### MILWAUKIE DESIGN AND LANDMARKS COMMITTEE Wednesday, October 23, 2013, 6:30 PM

**To:** Design and Landmarks Committee

**Date:** October 16, 2013, for October 23, 2013, Public Hearing

**Subject:** **File:** DR-13-05 (expansion of veterinary clinic use)  
**Applicant:** Alyssa Leeviraphan, Mahlum Architects  
**Owner(s):** Kim Freeman, 10400 SE Main LLC  
**Address:** 10400 SE Main St  
**Legal Description (Map & Taxlot):** 11E25CC00403  
**NDA:** Historic Milwaukie

EXTERIOR ELEVATIONS

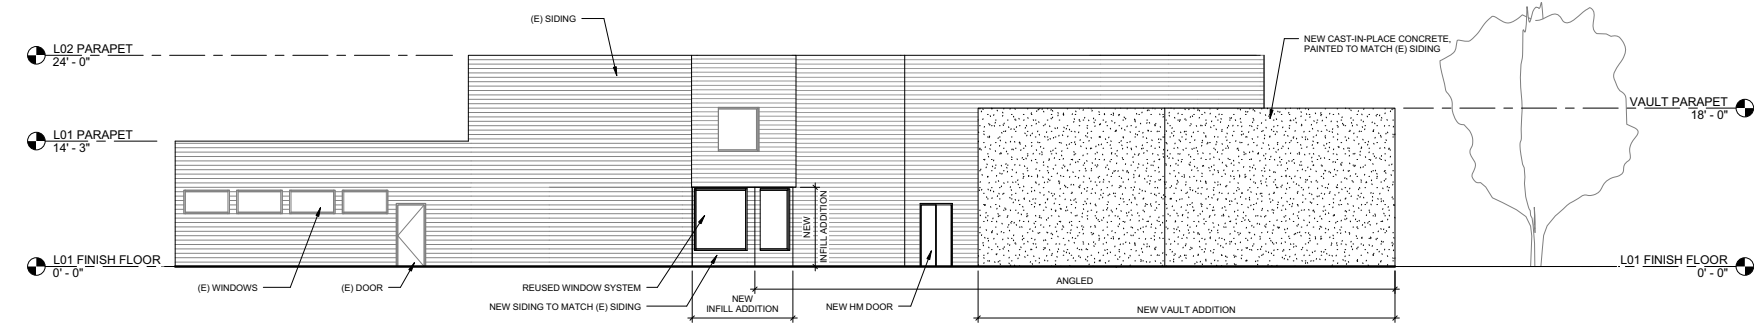
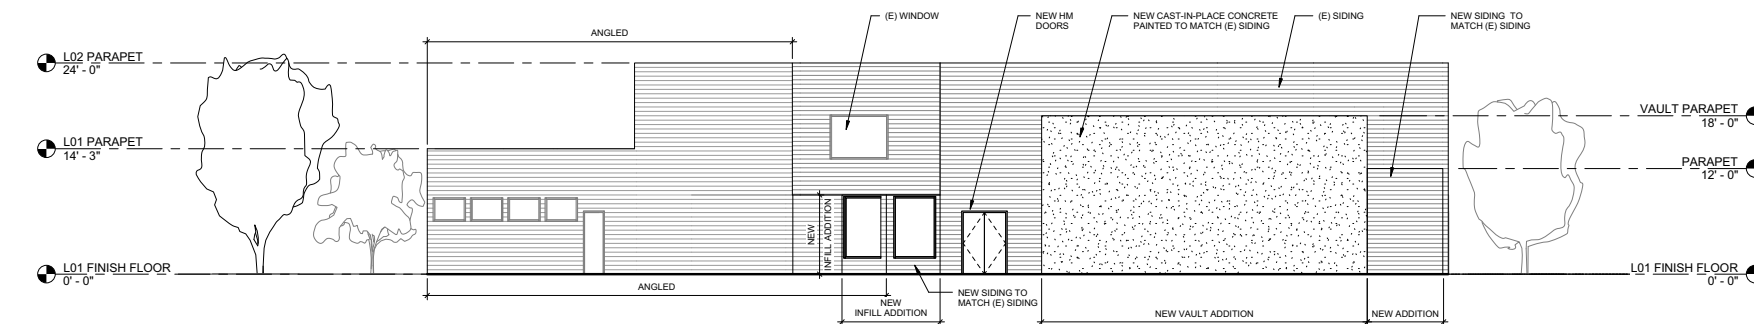
The proposed Phase II addition (the linear accelerator, control room, and modulator) has a flat roof. Per 19.304.6.4.a, flat roofs must include a cornice of 6 in deep and 12 in high. The proposed roof design does not include a cornice, and applicant has requested a modification to this standard.

b. MMC 19.907.10 establishes the process and criteria for modifications to the downtown design standards. MMC 19.310.C.4.a requires that all buildings with flat roofs include a cornice of at least 6 in deep and 12 in high. The proposed roof of the Phase II addition (the linear accelerator, modulator, and control room) is flat, and it does not include a cornice. Therefore, a modification to the design standards for roofs is required.

The existing building is a contemporary design with a flat roof. The requested modification would allow for the use of a flat roof on the proposed Phase II addition to the southeastern façade. This addition will be constructed of cast-in-place concrete walls in order to provide the needed radiation shielding for the linear accelerator. This type of construction is not conducive to this type of detailing, nor would it integrate well with the overall design of the existing building, which does not include cornices.
